# United States Department of the Interior

August 20, 2013

**NPS Comments on the 2009 Texas Regional Haze SIP not addressed in the 2013 draft  
Regional Haze Progress Report**  
August 19, 2013

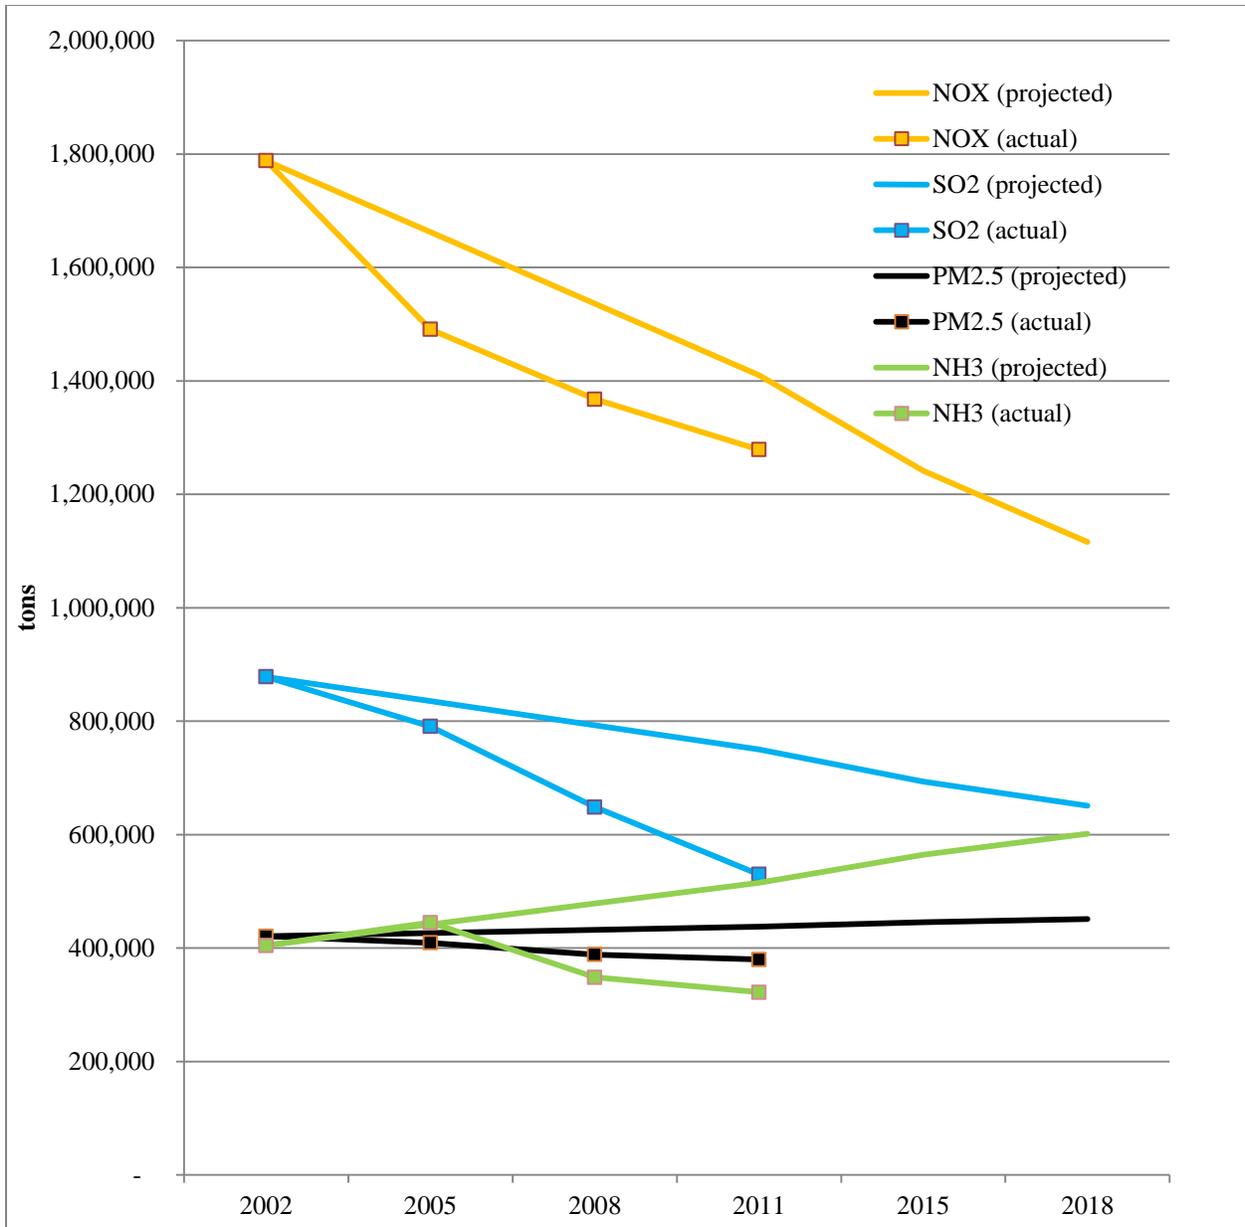
CENRAP modeled 111,853 tpy of SO<sub>2</sub> from area sources, and 974,457 tpy SO<sub>2</sub> from all sources in 2002. The 96,000 tpy error is almost 10% of the SO<sub>2</sub> total. Figure 4-1 of the Progress Report appears to have used the erroneous value for 2002 SO<sub>2</sub>; if that is true, then Figure 4-1 should be revised to use the correct value.

CENRAP appears to have carried the area source SO<sub>2</sub> overestimation into 2018<sup>1</sup> by estimating 114,138 tpy; this is a 2% increase in these incorrect emissions. Applying that same 2% increase to the correct 2002 area source SO<sub>2</sub> emissions yields 15,952 tons, a difference of 98,156 tpy, This corrected value should also be reflected in Figure 4-1 of the progress report.

Although Tables 4-1 thru 4-3 in the Progress Report show much lower (corrected?) values for area source SO<sub>2</sub> between 2005 and 2011, the 2002 and 2018 endpoints in Figure 4-1 continue to show the overestimated area source SO<sub>2</sub> estimates. We also question the value of including CO in Figure 4-1 because it causes the vertical axis to be compressed. Instead, we suggest showing ammonia emission trends because background ammonia concentration is a critical factor in particle formation. We have included below an example of how Figure 4-1 might look with corrected estimates for area source SO<sub>2</sub> and ammonia emissions (instead of CO). Our results indicate that actual emissions are tracking below the future projections.

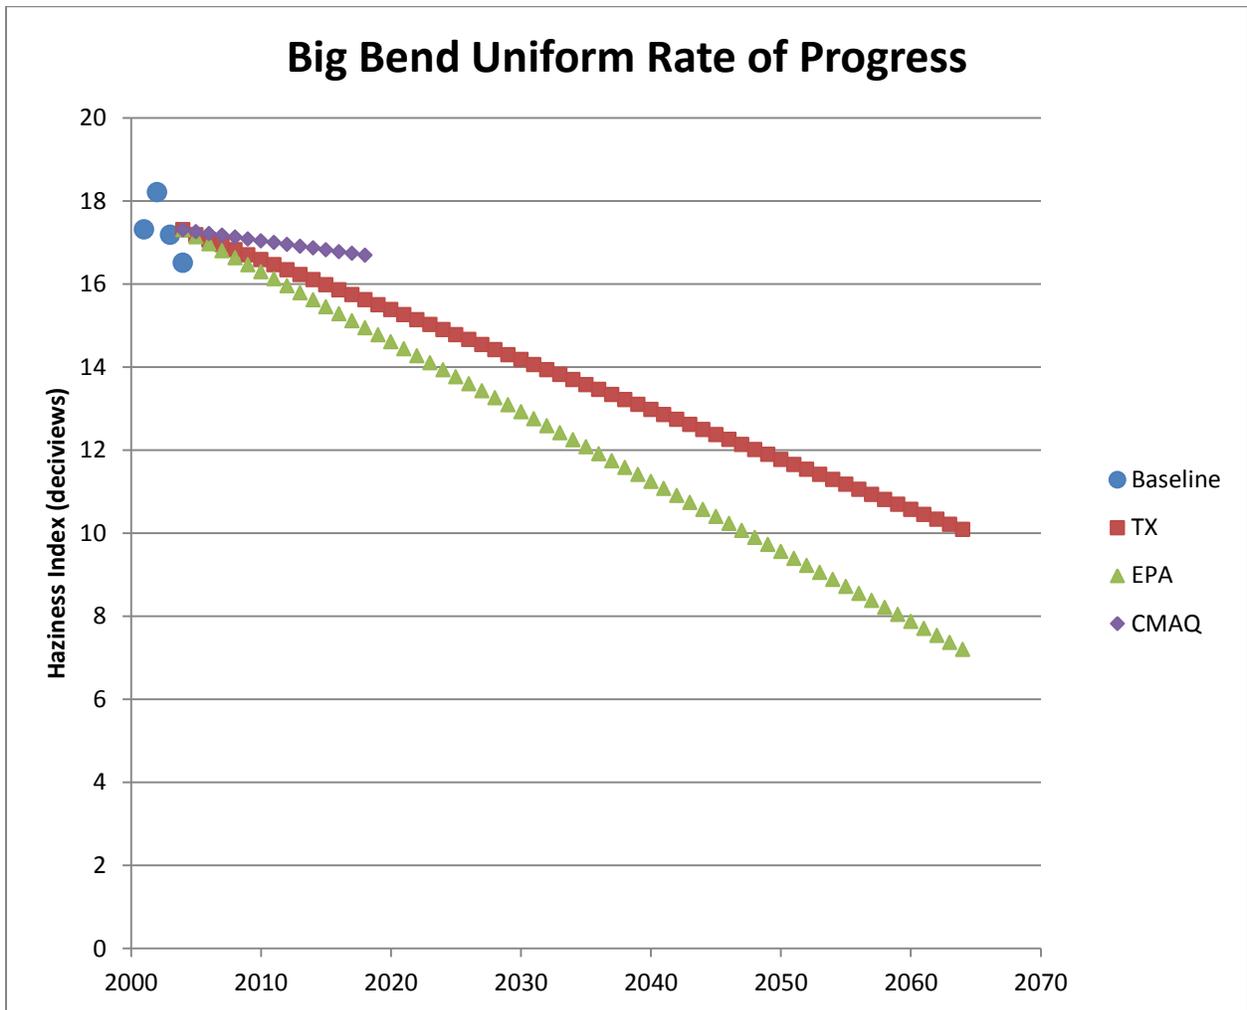
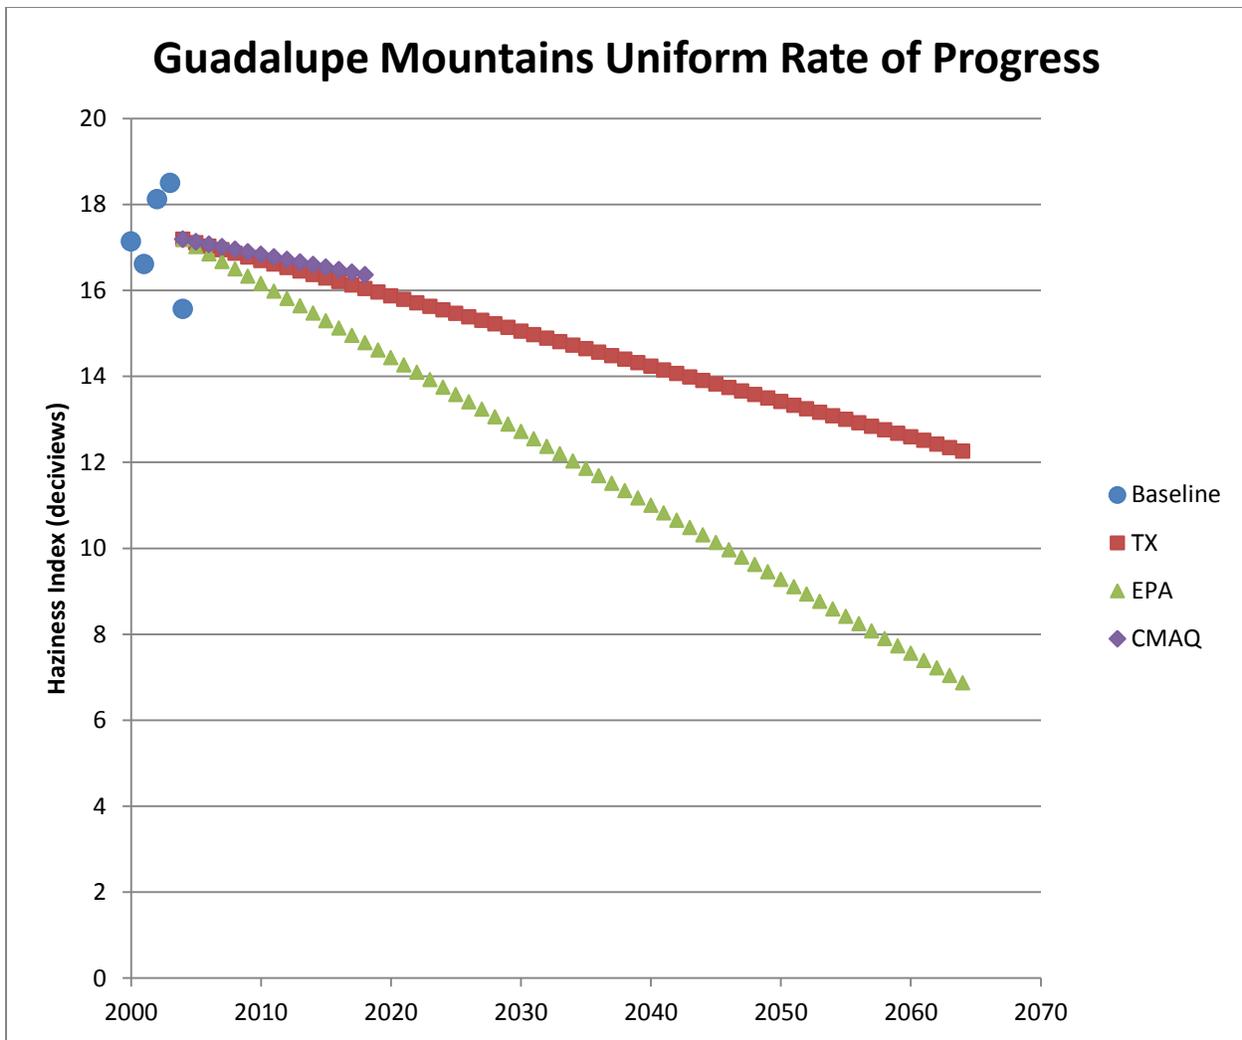
Because TCEQ declined to show the EPA default glidepath in the SIP main text or the Progress Report, we are providing that information for public review.

**The comparisons with the EPA default, or more specifically, the Natural Conditions II (NC II) committee's estimates using the New/Revised IMPROVE Algorithm, are available in Appendix 5-2. The commission made some changes in response to this comment, however the NC II estimates will remain in the appendix.**

### CENRAP Projected 2018 Worst Days at BIBE

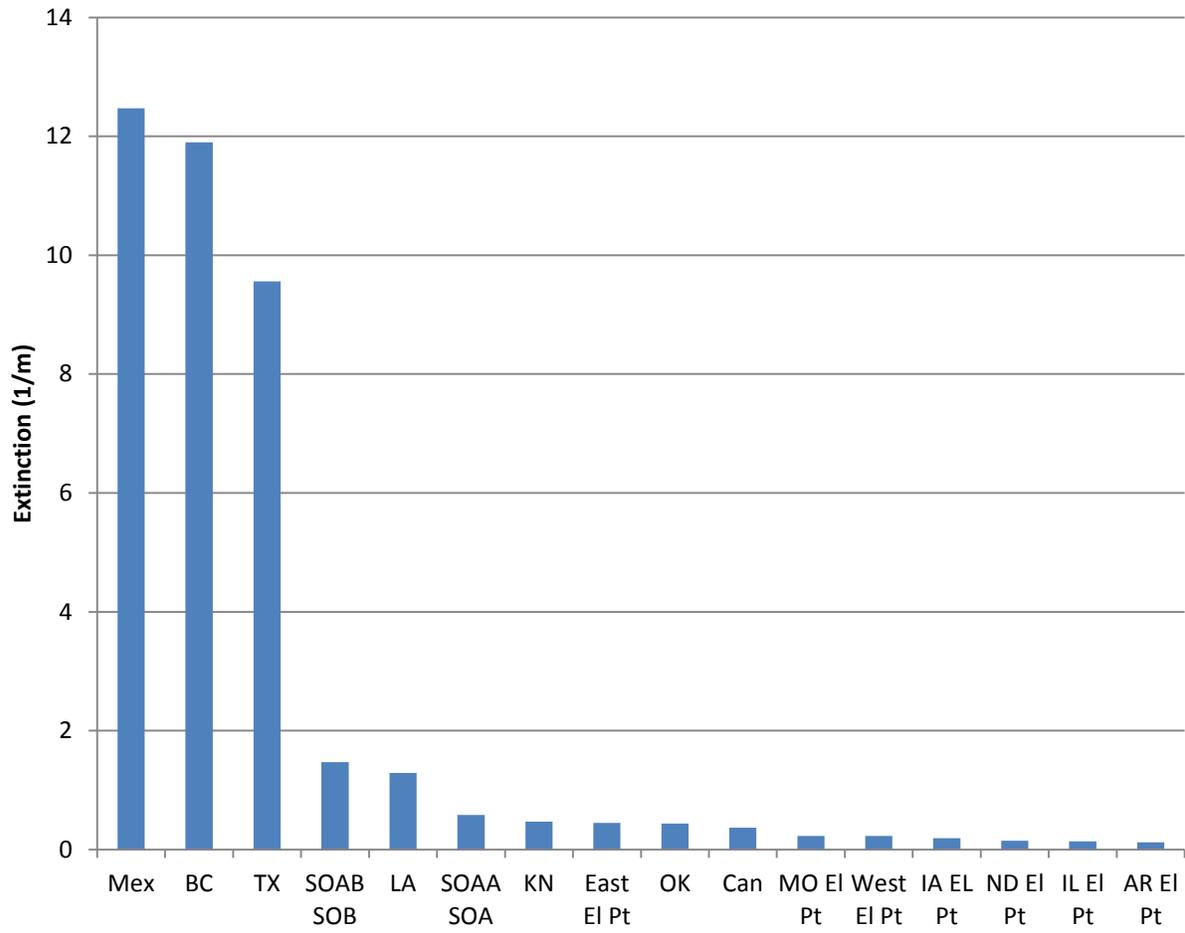
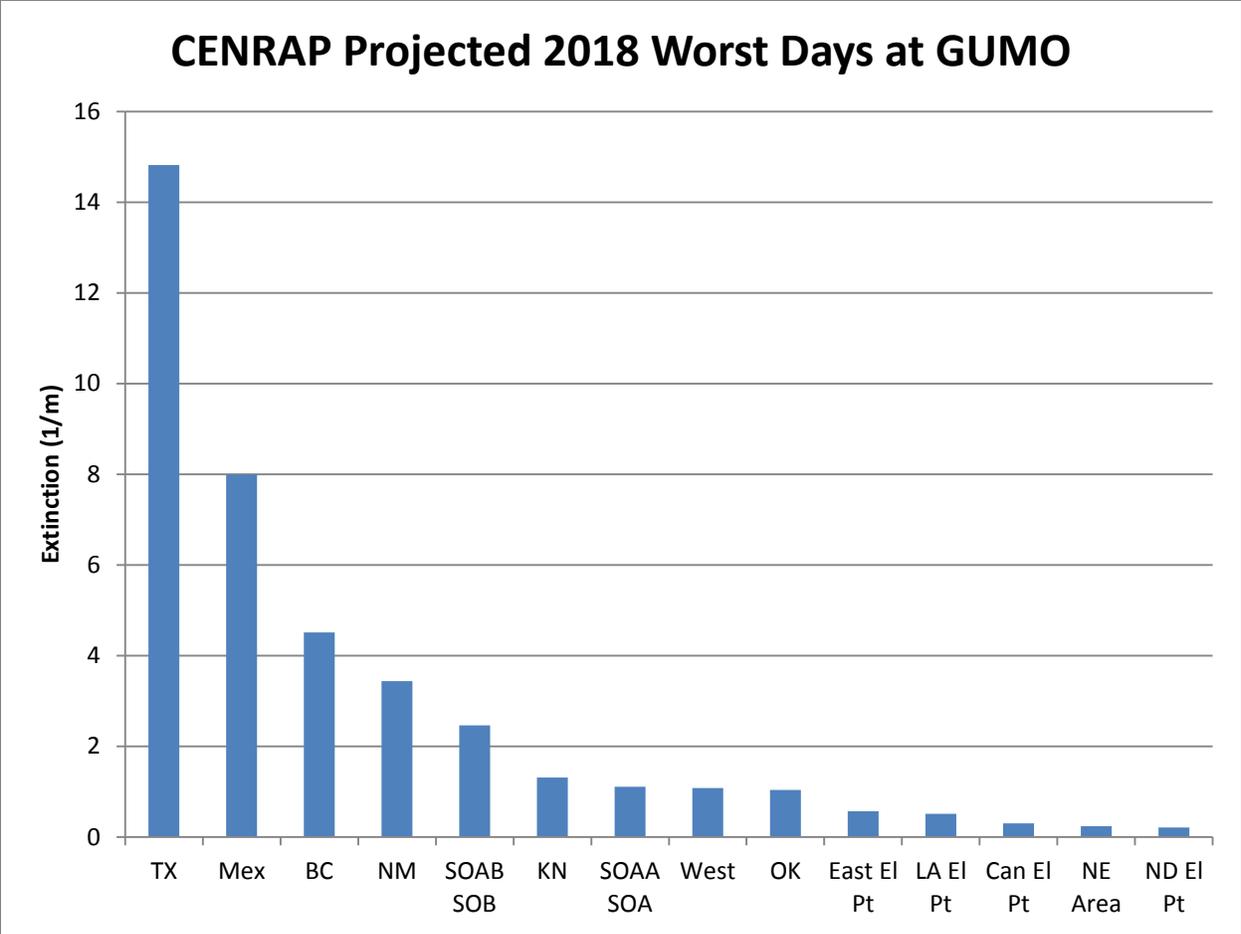
It is clear from these charts that Texas contributes more to visibility impairment at these national parks than any other state.
